# Town of Poughkeepsie

### A.5. 51 VASSAR ROAD

**SEQRA Review, Site Plan Review, and Architectural Review** for the redevelopment of a parcel to include construction of a ±10,640 square foot building for retail use. 51 Vassar Road; Red Oaks Mill Neighborhood Services Center (ROMNSC) Zoning District; ±4.58 acres; Grid #: 6260-04-565213; Unlisted Action; *Calito Development Group, LLC c/o Matt Eucalito (Applicant) and Oak Mill Plaza LLC c/o Vincent Destaso (Owner)*.

**Re: Amended Site Plan for Calito Development Group, LLC**  
**51 Vassar Road, Poughkeepsie, NY 12603**  
**Parcel ID #134689-6260-04-565213**

2 PROPOSED SITE PLAN  
1" = 40'

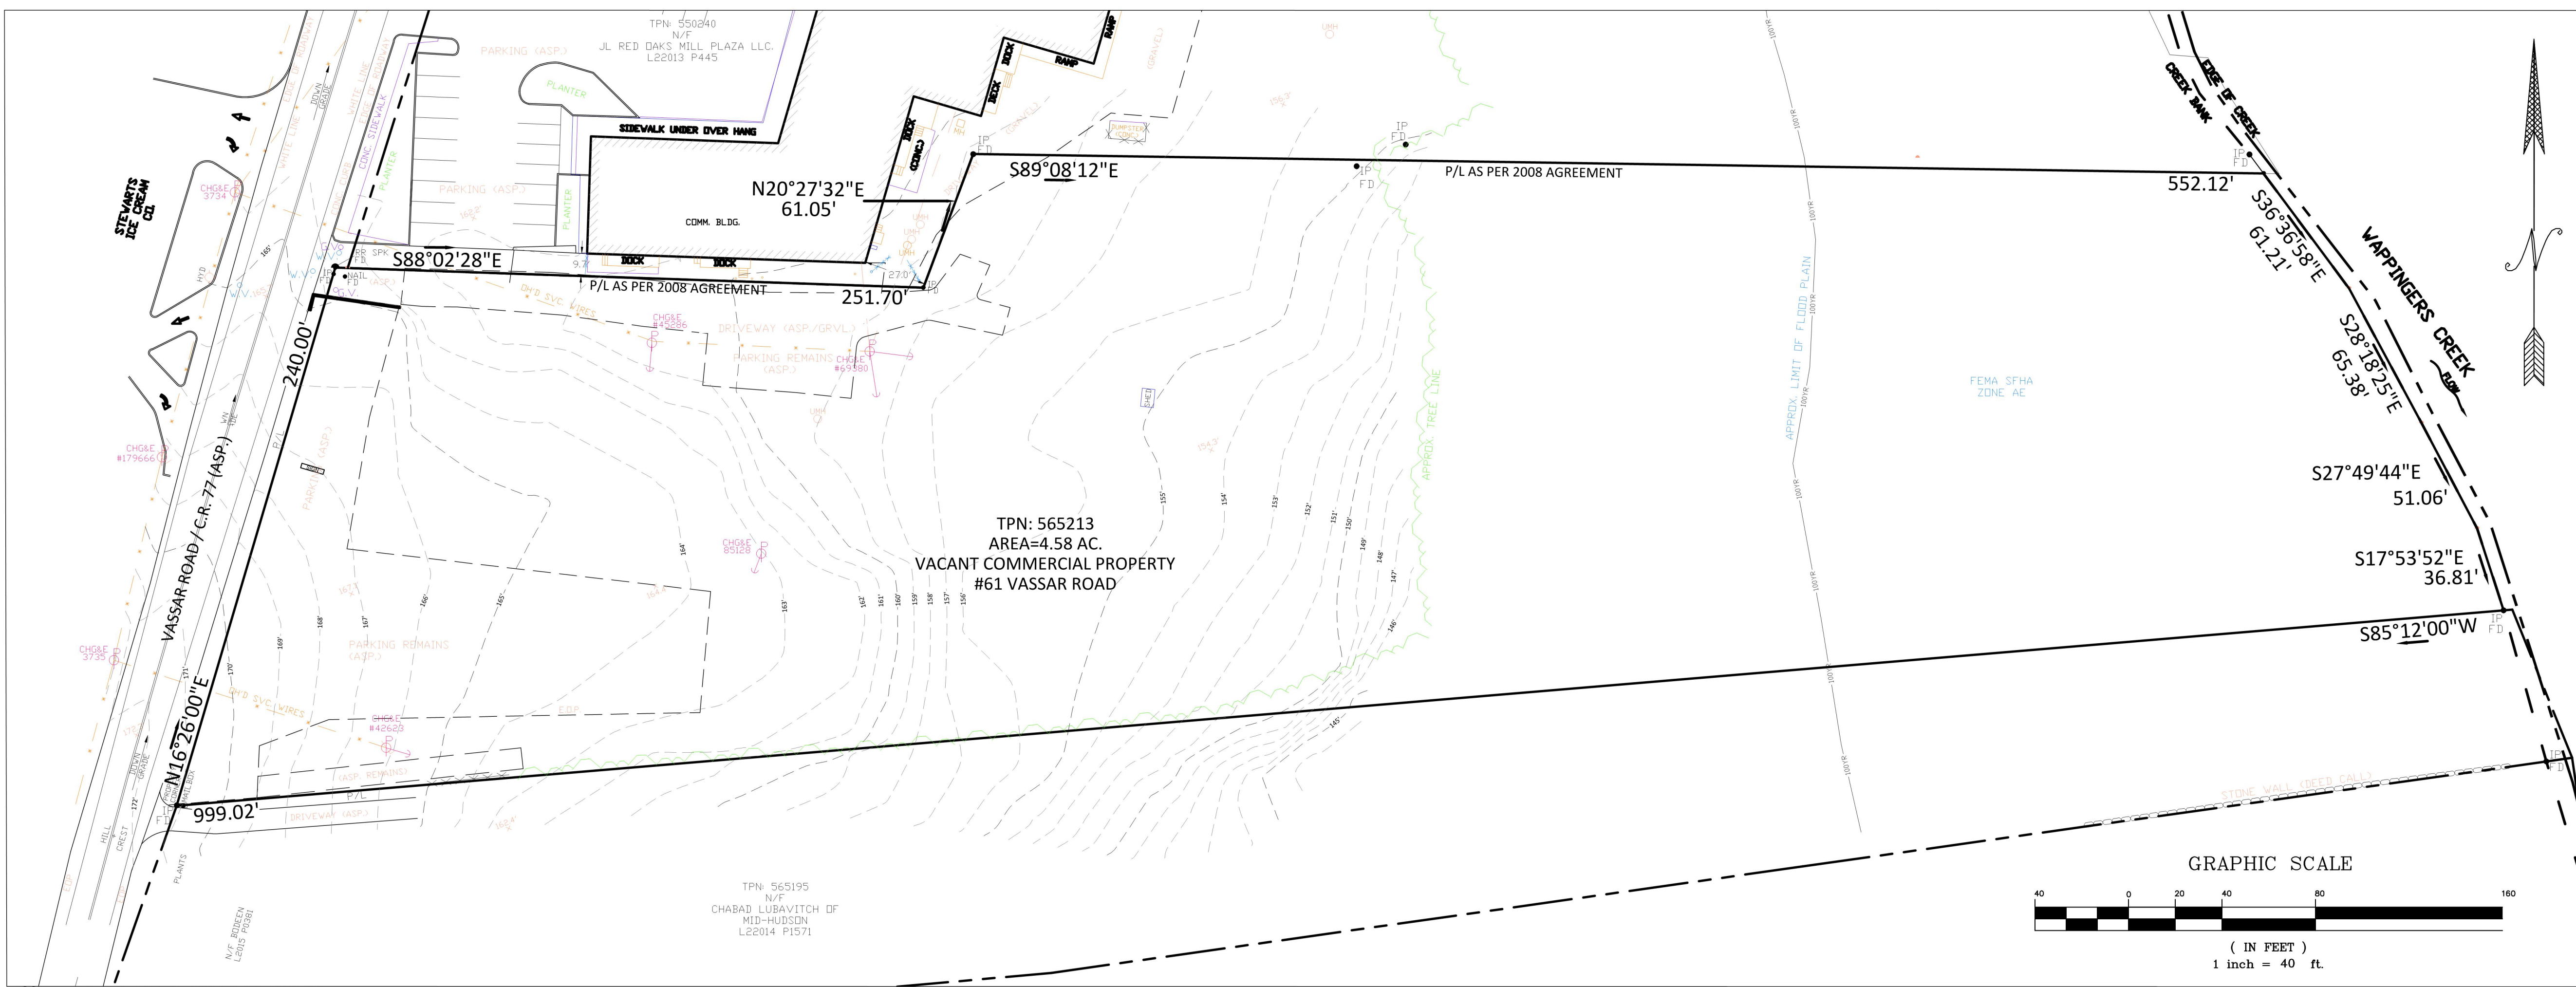
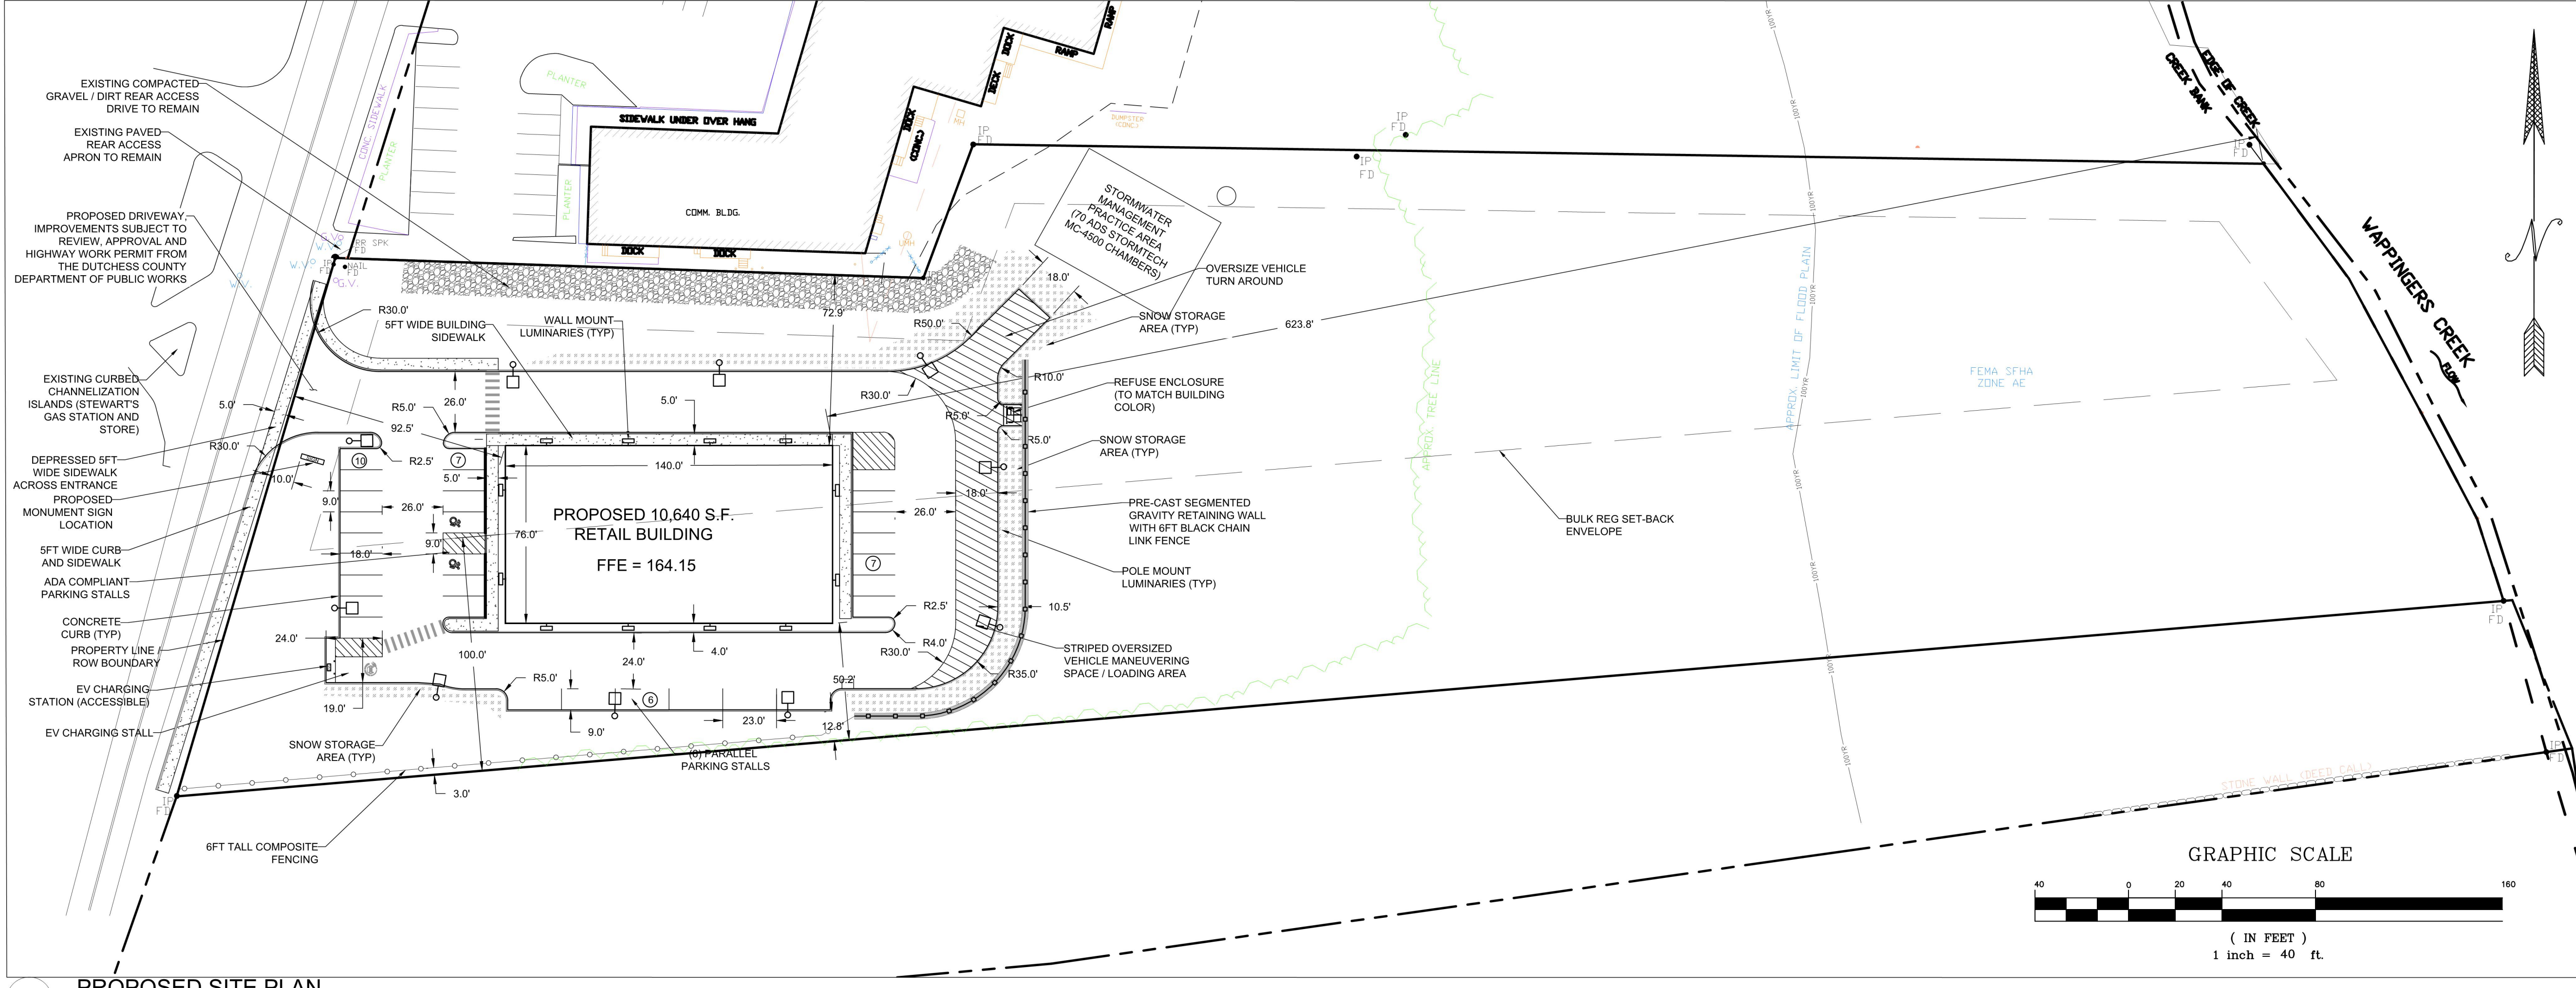
1. Sheet CS101: Applicant to document any area variances with the area and bulk table as a result of this review.
2. Sheet CS101: Applicant, per Planning Board and staff advisement, is now proposing the placement of a sidewalk along the “front” of their property along Vassar Road. Given that Dutchess County has jurisdiction over this portion of roadway, the applicant will be required to coordinate maintenance agreements and otherwise with the appropriate County departments.

3. Sheet CS101: Applicant shows sidewalk and internal connections throughout the site. Applicant to show on the site plan where drop curbs are proposed with detectable warning pads. Provide details accordingly.

4. Sheet CS101: Applicant to label the existing driveway dimension on the site plan. Applicant does not appear to propose to repave or define this driveway as part of this project’s scope. This driveway falls within the 51 Vassar Road parcel. In a response to comments regarding fire truck access, as it relates to quality and composition of the gravel/dirt road here, and seeking confirmation that this is acceptable to the Arlington Fire Department, the applicant notes that it is beyond the scope of this application. Staff respectfully disagree with this approach to the application. This comment is not solely about emergency access. The applicant plans to provide a sidewalk along Vassar Road within their property limits. There is no plan to make an accessible connection to the existing sidewalk to the north of the existing driveway that is to remain. Additionally, there are a handful of plantings proposed along the northern side of the proposed new northern driveway for the proposed Dollar General. Again, this area should be further defined and/or landscaped.

5. Sheet CS101: Applicant to confirm that the new driveway layout is not going to impede vehicle circulation on the parcel to the north. Arlington Fire Department and refuse hauler access to be maintained.

- b. *Applicant to confirm that the proposed compacted dirt is sufficient for the weight of emergency vehicles*
6. Sheet CS101: Applicant to confirm parking demand. Are the proposed parallel parking spaces needed? Additionally, there is limited connection between these parking spaces and the proposed building entrance. Sidewalk along the building frontage should include a drop curb and warning pad to the south.

7. Sheet CS101: Applicant is proposing an electric vehicle charging station along Vassar Road. While staff commend the proposal of this technology, the location proposal should also consider the size of the proposed charging station, any signage, and transformer placement and/or any other required equipment and screening. Is there any alternate place for the charging station?

8. Sheet CS101: Applicant to place a note on the plan that confirms that there will no storage of materials outside on the sidewalk, storefront, without proper approvals from the Town.

9. Sheet CS101: Applicant is proposing a loading area at the back or east side of the proposed building. Applicant to confirm that there is a drop curb for deliveries. Are all deliveries going to fit through a normal doorway? Additionally, is the striping along the eastern pavement necessary? Applicant to consider just painting “loading zone” on the pavement.

10. Sheet CS101: Applicant to confirm that there is no proposal or need for a compactor on site and that normal waste/recycling containers are proposed for the refuse enclosure.

11. Sheet CS101: Applicant to provide an elevation view of the proposed retaining wall and black chain link fence. The Planning Board will want to know what this looks like, how high the wall sits with the proposed chain link fence.

**Response: We will continue to work with the board on any required variances from the ZBA or waivers from the Board once the layout is tentatively finalized. A note has been added to sheet CS101 beneath the bulk regs.**

**Response: This request is now noted on sheet CS101**

**Response: We are seeking relief in the form of a waiver from the planning board on this requirement given the limitations of the parcel and fact this was previously developed up to the property lines on three sides. This request is now noted on sheet CS101**

**Response: This request is now noted on sheet CS101**
